# H TECHNICAL BULLETIN INTRAAX TRAILER AIR SUSPENSION LOWER SHOCK MOUNT REVISION

No: TRAILER AUS - 012  
Subject: Product Update  
Date: February 1999 Revision: A

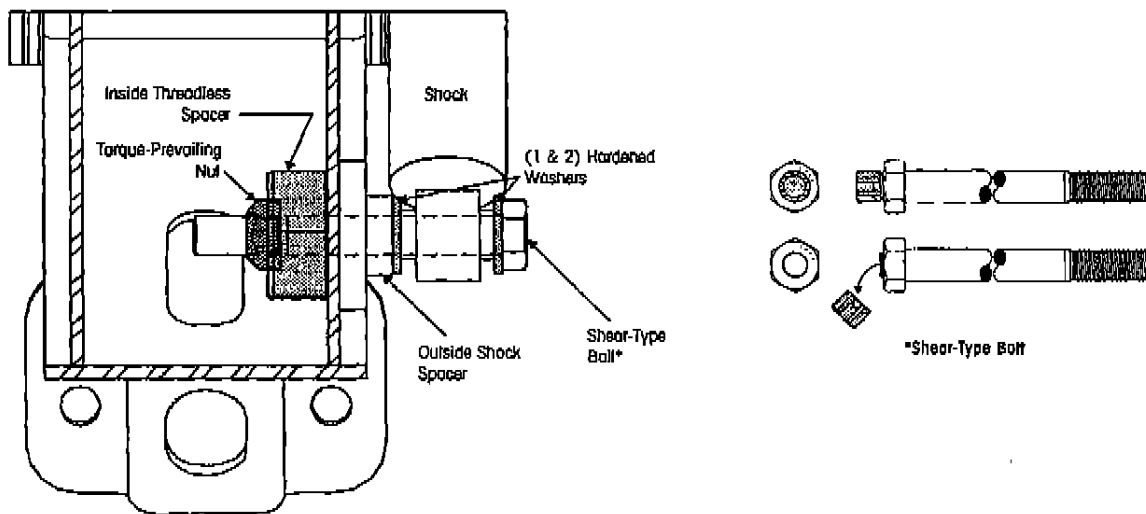
Effective March, Hendrickson will make the following changes to improve product reliability. (ref figure)

- ? Shear type, coarse thread bolt to ensure proper torque. (Part No. B-24058-1)
- ? New shock absorber with stronger inner metal bush to withstand higher torque. (Part No. S-24023)
- ? Additional hardened washer between spacer and shocker.
- ? Revised spacers with more support inside and outside beam.
- ? Torque prevailing nut tack welded to the spacer inside the suspension beam.

The current design utilises a large nut with threads inside the beam. The current nut will be replaced with a similar spacer block with no internal threads. A torque prevailing nut will be tack welded to the spacer to accept the new shear bolt.

The shear bolt is a convenient feature to achieve the correct clamp load. The bolt is designed to torque at 210-235 ft-lbs. Proper torque is critical to the life of these shock mounting connections.

New shocks are also being introduced with this design. (Part No. S-24023). The inner metal in the bushing area has been strengthened to withstand the higher fastener torque. The form, fit and function of these shockers will not change.

The new shocks may be used in place of present shocks, however older shocks must not be used with the new shock mount design.
